SCHWEIZER SERVICE NOTICE

NOTICE NO. N-184.1*

SUBJECT: PERIODIC CHECK AND INITIAL REPLACEMENT - BELT DRIVE PULLEY
H-FRAME TIE BAR BRACKET ASSEMBLY, PN 269A5517-7

Figure 1. Installation of 269A5517-13 H-frame tie bar bracket assembly

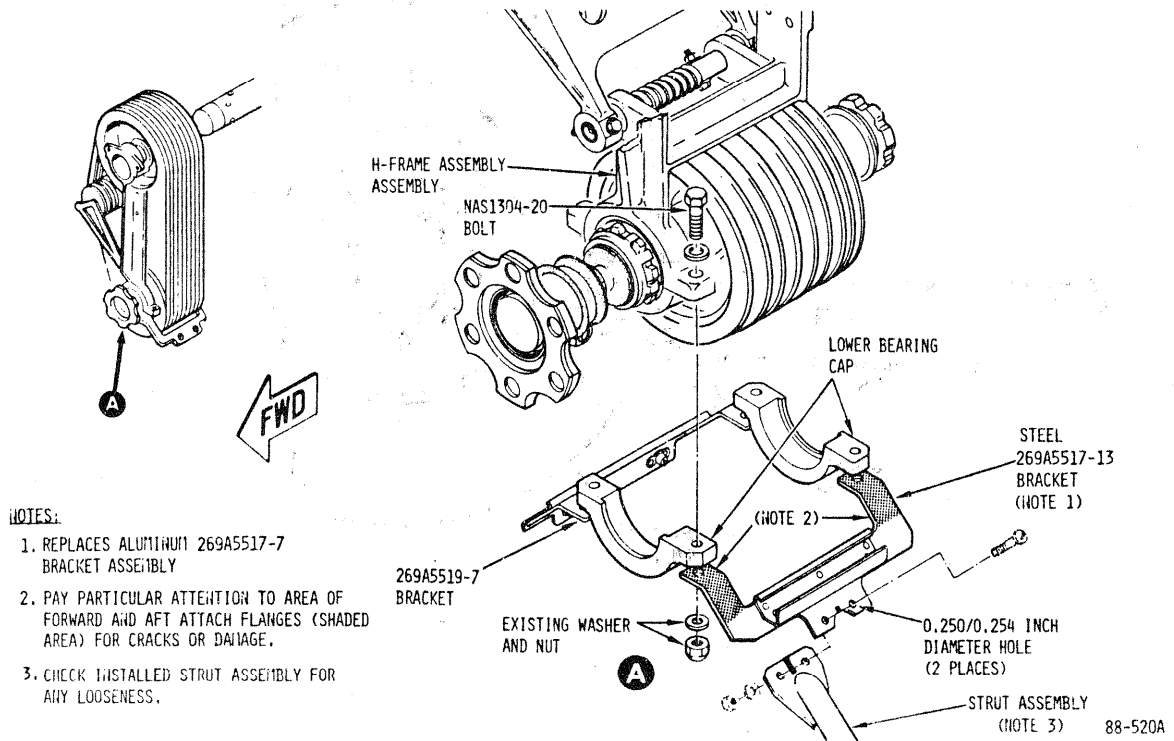
- a. With belt drive cover installed, visually check the FORWARD attach flange of the H-frame tie bar bracket assembly for cracks or damage. (See Figure 1.) Also check AFT attach flange of bracket, if PN 269A5471-13 fiber-glass belt drive cover is installed; use slot in cover for visual check.

- b. Check strut for looseness. (See Figure 1.) If any looseness is noted, perform the following:

- a. Remove V-belt drive cover shell and hat, per Section 10, Basic HMI.
- b. Remove hardware securing existing 269A5517-7 aluminum bracket assembly to H-frame lower bearing caps. (See Figure 1.) Remove and discard bracket assembly.

- e. Install strut to center frame fitting using existing hardware.
 - f. Align strut with attach clip on new 269A5517-13 bracket assembly. (See Figure 1.) Using holes in strut as template, mark and drill two 0.250 - 0.254-inch diameter holes in bracket as shown. Use No. E drill. Remove burrs as required and apply zinc chromate primer.

Figure 2. Shimming Requirements PN 269A5517-13 Bracket Installation, 269A, 269A-1, 269B and 269C (S/N 0004 - 0589 only) Helicopters.

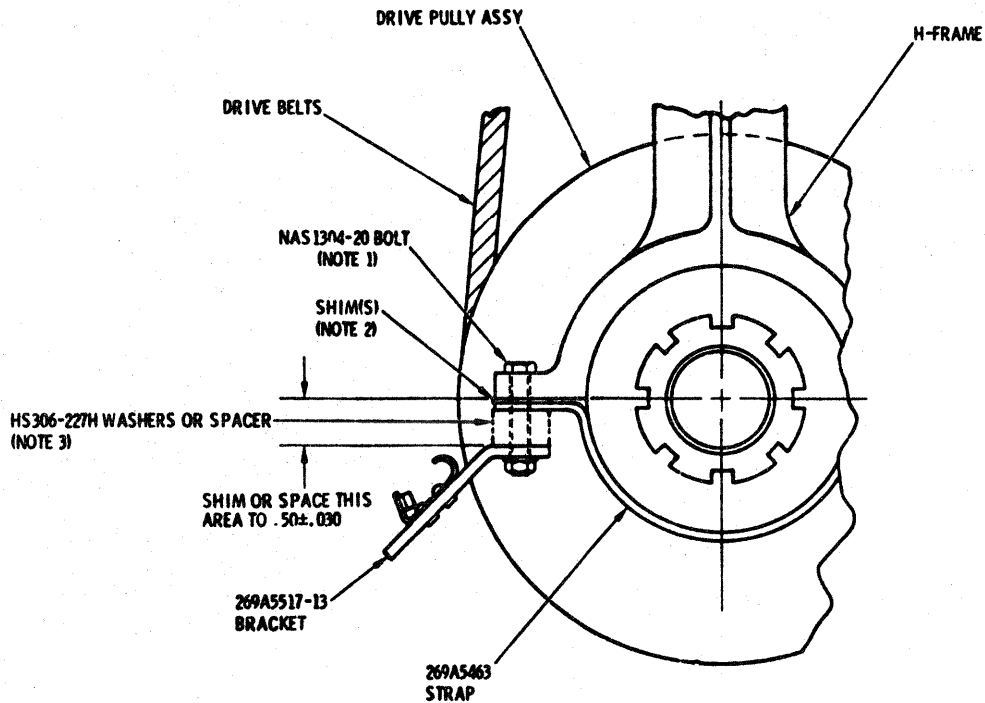
- c. Install 269A5517-13 on 269A, 269A-1, 269B, and 269C (S/N 0004-0589 only) as follows and as shown in Figure 2:
 1. Discard AN4-11A bolts removed in step b.
 2. Ensure shimming between 269A5463 strap, and flange of H-frame as specified in step r of Hughes Notice N-164 has been accomplished.

3. Determine number of HS306-227H washers required, or fabricate a spacer (0.80-0.85 inch outer diameter, 0.256-0.270 inch inner diameter) from 300 Series or 17-4PH stainless steel plate or rod, to establish 0.050 ± 0.030 inch distance between facing surfaces of H-frame flange and 269A5463 strap. (See Figure 2.)

1. REPLACE EXISTING AN4-11A BOLT WITH NAS 13/16-20 BOLT.
2. ENSURE SHIMMING PER STEP r, HUGHES NOTICE N-164 PRIOR TO DETERMINING NO. HS306-227H WASHERS OR LENGTH OF SPACER REQUIRED.
3. FABRICATE SPACER (0.80 - 0.85 INCH OD, 0.256 - 0.270 INCH ID) FROM 300 SERIES OR 17-4PH STAINLESS STEEL IF DESIRED.
4. BOLT REPLACEMENT AND SHIMMING REQUIRED AT EACH END OF 269A5517-13 BRACKET.

4. Install 269A5517-13 bracket using NAS1304-20 bolt, shims between strap and H-frame flange, shims or spacer between bracket and strap, and remaining hardware removed in step b. Torque bolt to 50 to 70 inch-pounds.
